REMARKS/ARGUMENTS

Appl. No. 10/721,694
Reply to Office Action of March 24, 2005
Annotated Sheet Showing Changes

Fig 2

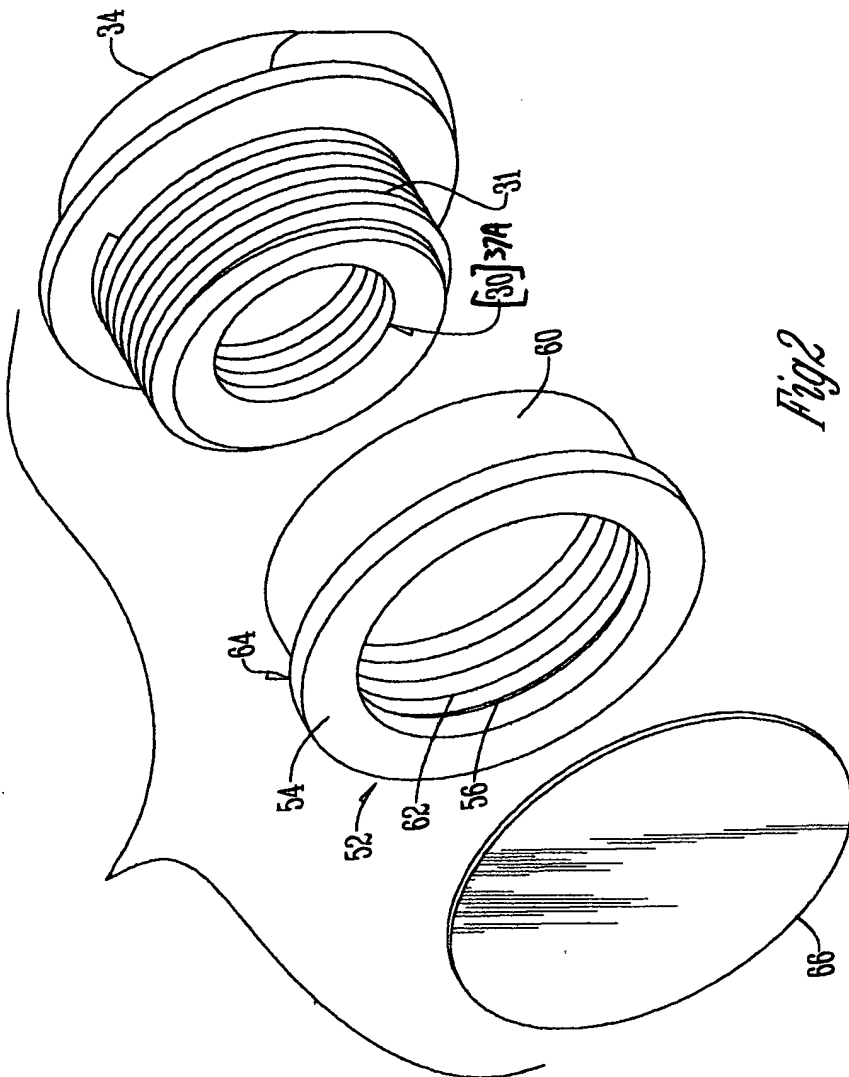
The attached sheet of drawings includes changes to Figs. 2 and 3. This sheet, which includes Figs. 2 and 3, replaces the original sheet including Figs. 2 and 3. In Fig. 2, previously omitted element 37A has been added. In Fig. 3, previously omitted elements 37A and 37B have been added.
